**RE: 2451 – 2455 Danforth Avenue, Mixed-Use Development – OPA / ZBA – Response to Comments**

### 3.0 RESPONSE TO COMMENTS

City of Toronto staff provided comments in response to the November 2024 Urban Transportation Considerations Report prepared by BA Group.

FIGURE 3 WESTLAKE ROAD ON-STREET PARKING REVIEW

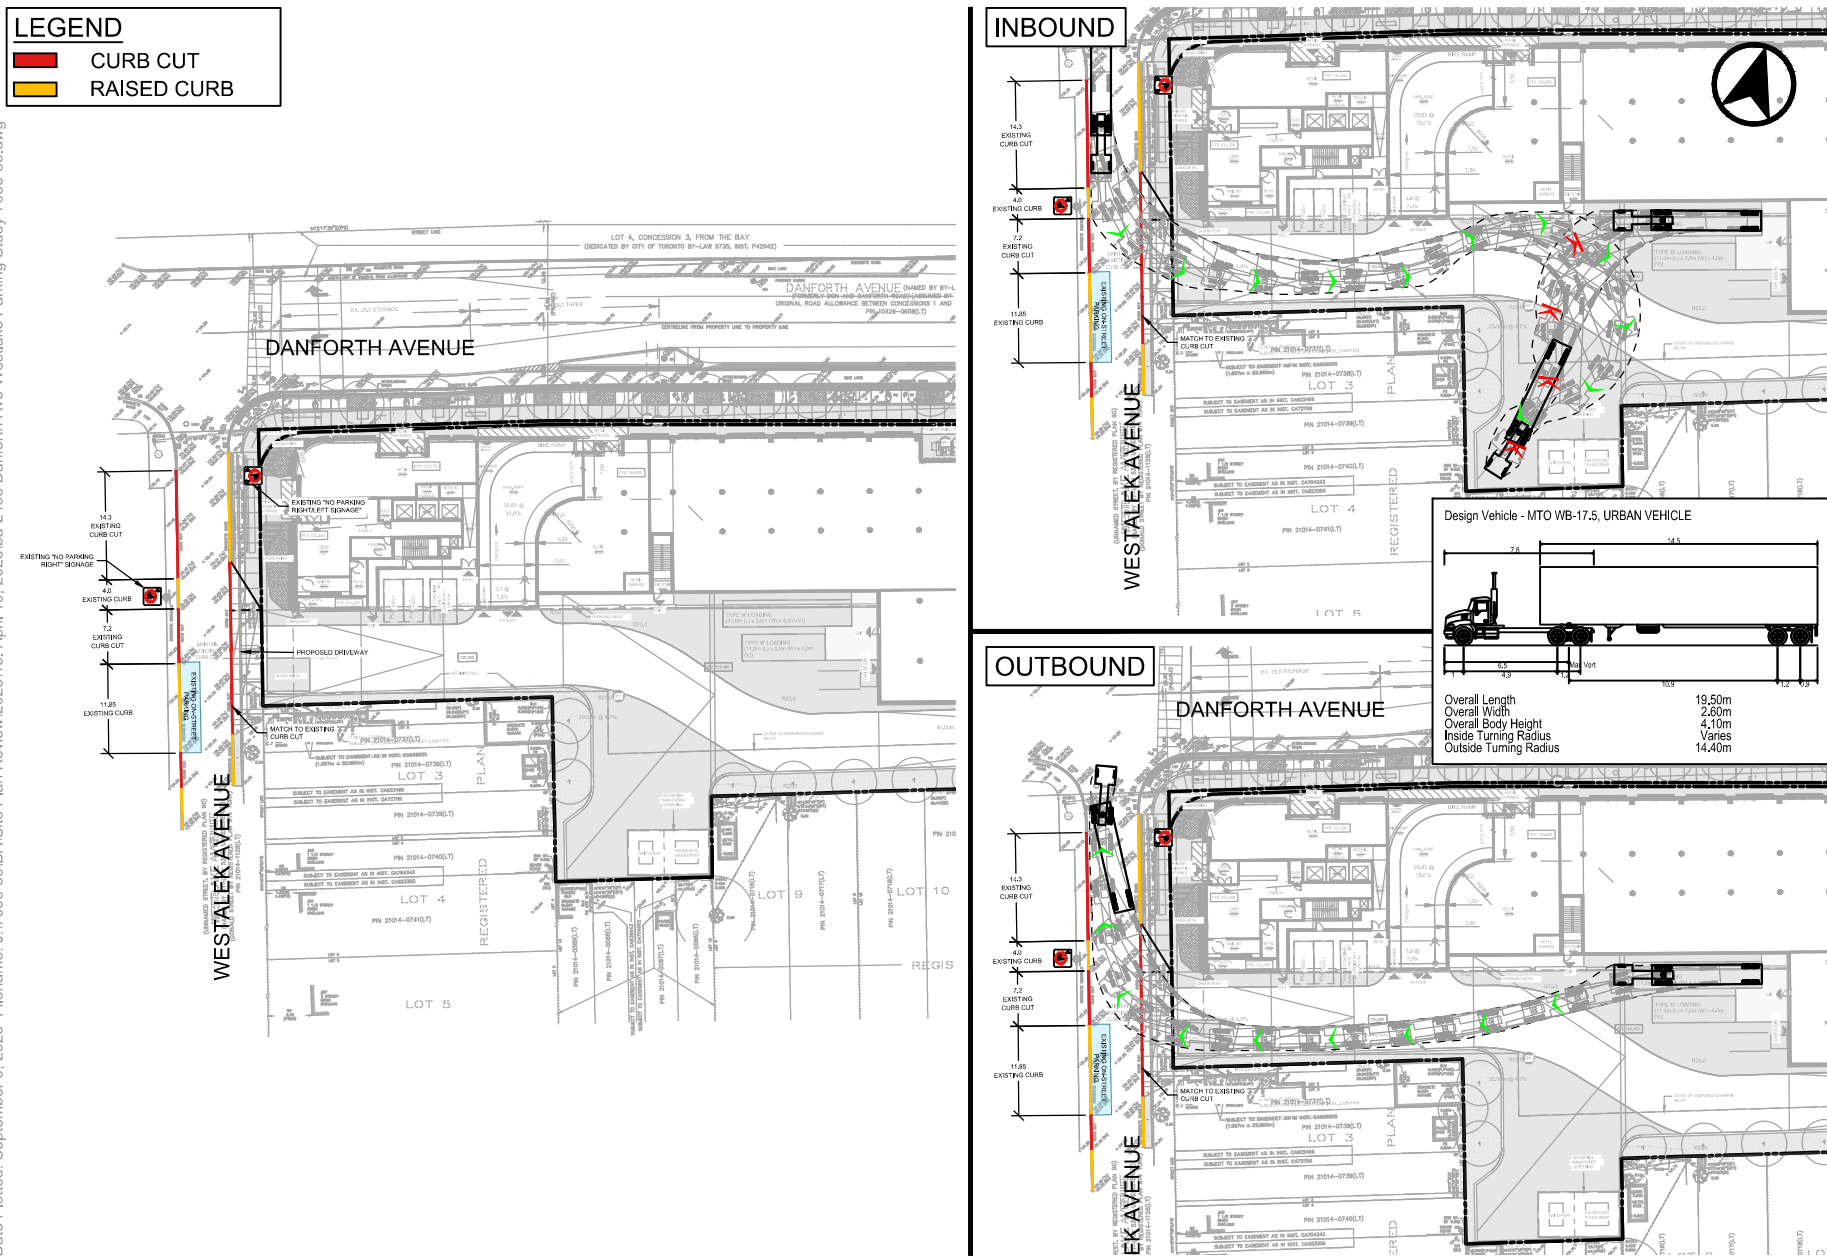
**Comment 1.4:** Confirm whether changes to parking regulation on Westlake Avenue are required to accommodate inbound and outbound truck movements.

**Response:** No changes to parking regulations on Westlake Avenue are required to accommodate inbound and outbound truck movements. Under existing conditions, curb cuts / driveways and no parking regulations limit the ability to park on Westlake Avenue (on either side of the street) for most of the site frontage.

Figure 3 demonstrates the location of existing curb cuts and no parking regulations in proximity to the site and that the proposed vehicle manoeuvres do not impact any existing on street parking.

Title:  
FLOOR PLAN - P1

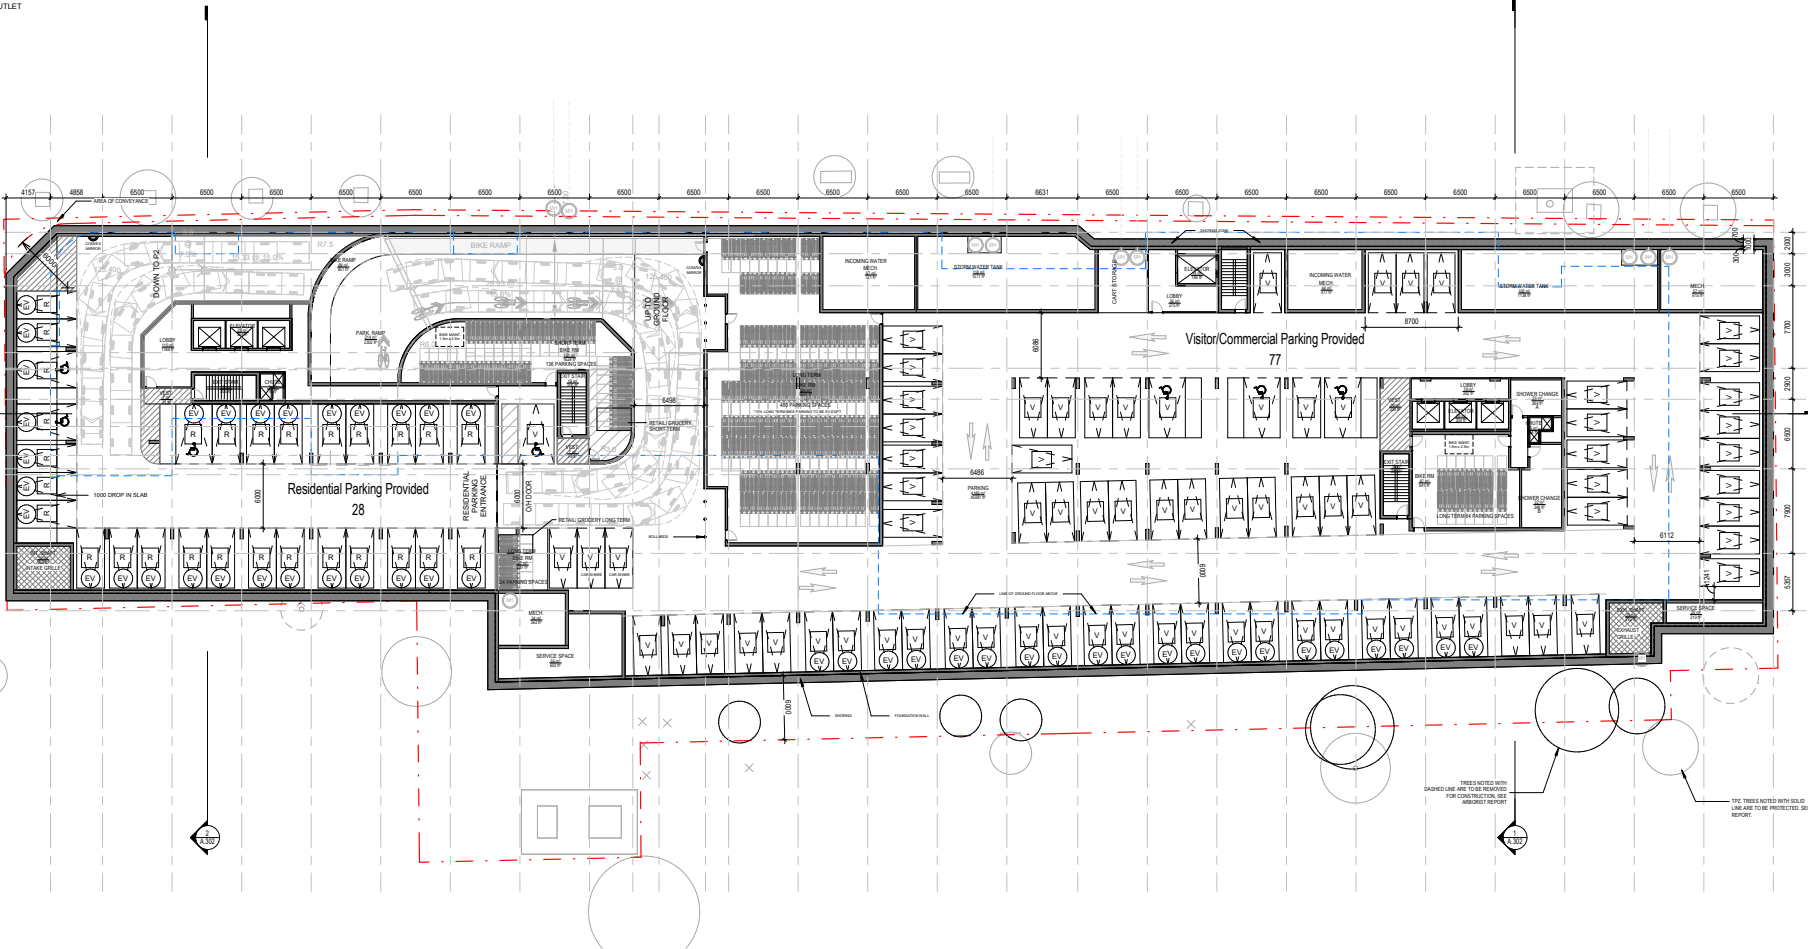
**Comment 1.2:** Provide a minimum of one (1) shower and change facility for each gender to meet the requirements of Zoning By-law 569-2013, chapter 230.

Chapter 230 requires one (1) shower and change facility be provided for each gender when five (5) or more long-term bicycle parking spaces are required for non-residential uses. The plans must be revised accordingly to meet the Zoning By-law requirements and encourage bicycle use by grocery/retail employees and other visitors to the building.

**Response:** Noted. One shower and change facility will be provided for each gender on the P1 level. Refer to update architectural plans included in Appendix A.

**Response:** Noted. One shower and change facility will be provided for each gender. Refer to update architectural plans included in Appendix A.

Title:  
**FLOOR PLAN - GROUND FLOOR**

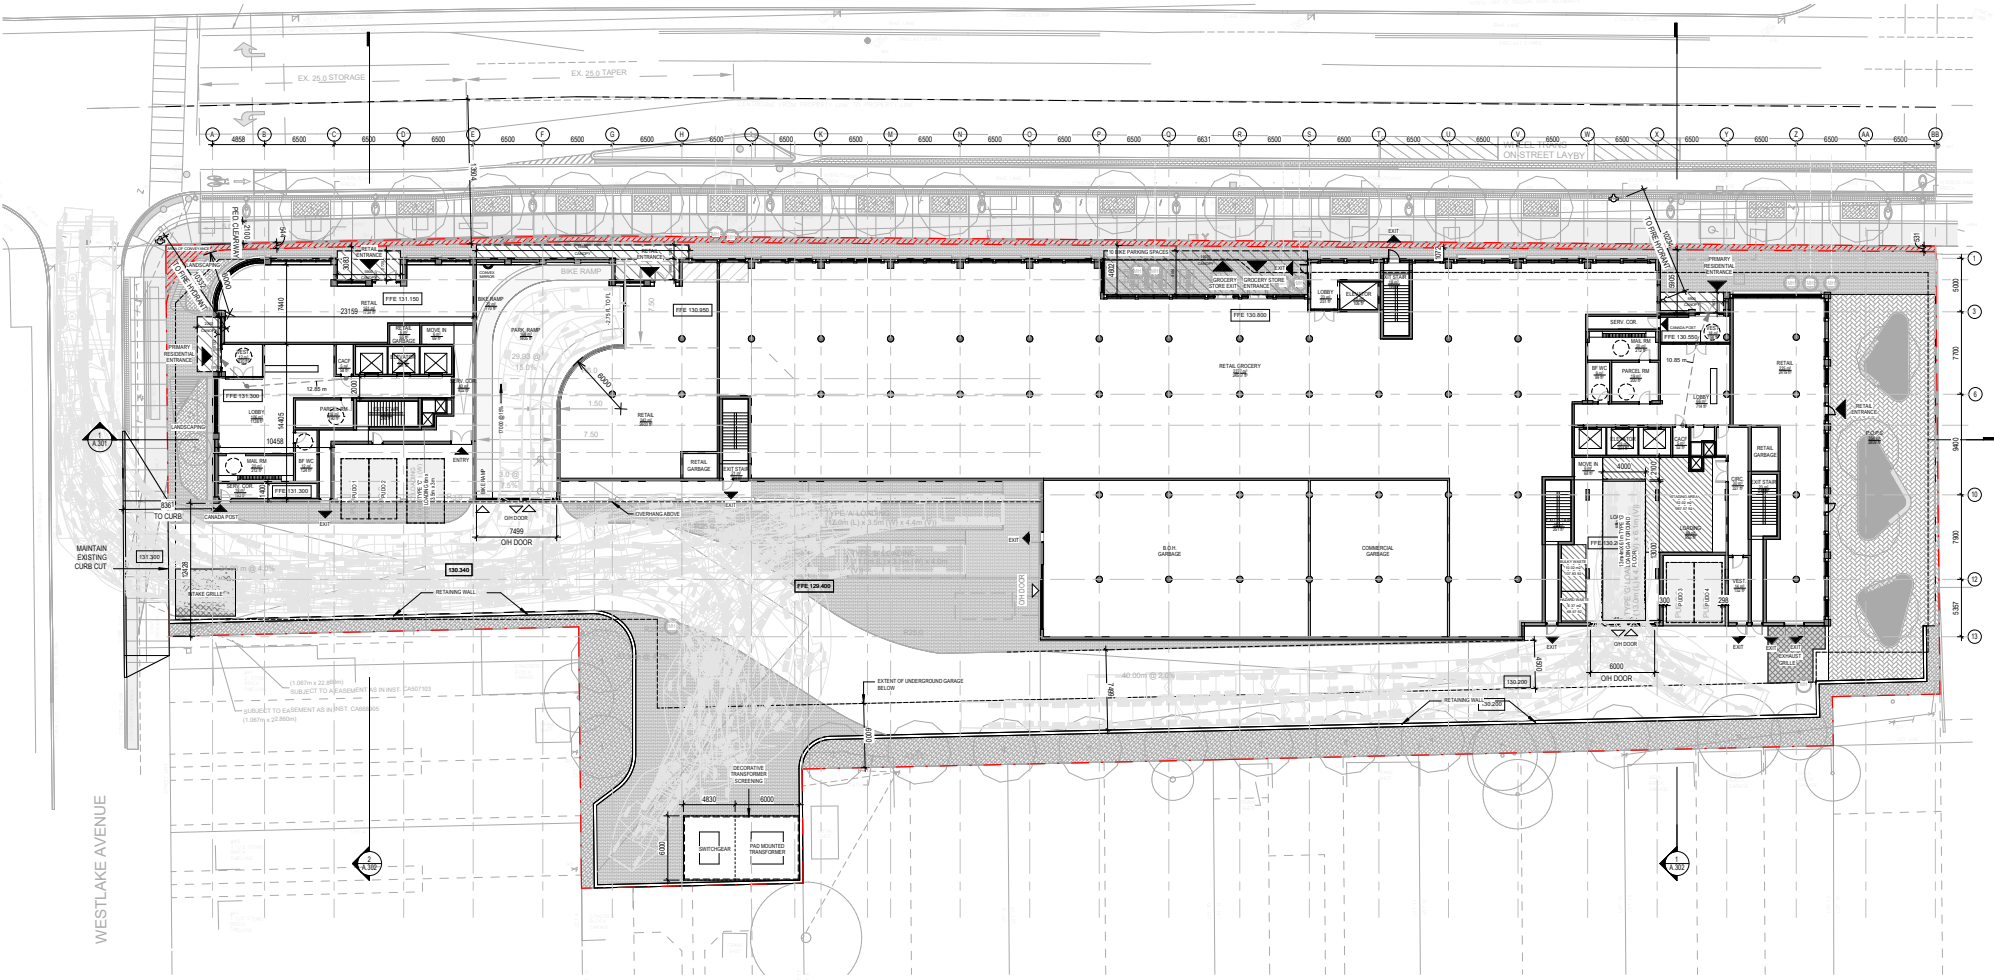
**Comment 1.3:** Revise all applicable plans to clarify and reduce the width of the driveway access, which should be as narrow as possible while accommodating the necessary truck manoeuvres.

**Comment 2.1:** Revised drawings must indicate and annotate that the staging pad is located at the front of the Type G loading space will be at least 62 square metres. Currently when measured under scale, only 33.66 square metres is provided.

**Comment 2.2:** Revised drawings must indicate an oversized storage area of minimum floor area of at least 10 square metres. It is encouraged that the oversized storage area be located within or with direct access to the loading area.

**Comment 2.3:** Revised drawings must show an additional 3.79 square metre, at a minimum for the storage of household hazardous waste.

**Response:** The proposed driveway width of 12.4 m is annotated on the updated architectural plans included in Appendix A. The proposed width of 12.4 m is required to accommodate all necessary truck manoeuvres. The existing curb cut, serving the adjacent 47 Westlake Avenue driveway (south of the proposed Site driveway), will be maintained.

**Response:** The updated architectural plans (Appendix A) indicate that the staging pad, adjacent to the Type G loading space, will be at least 62 square metres.

The updated architectural plans (Appendix A) indicate the provision of an oversized storage area with a minimum floor area of at least 10 square metres located adjacent to the Type G loading space.

**Response:** The updated architectural plans (Appendix A) indicate the provision of a 6.37 square metre storage area for household hazardous waste.
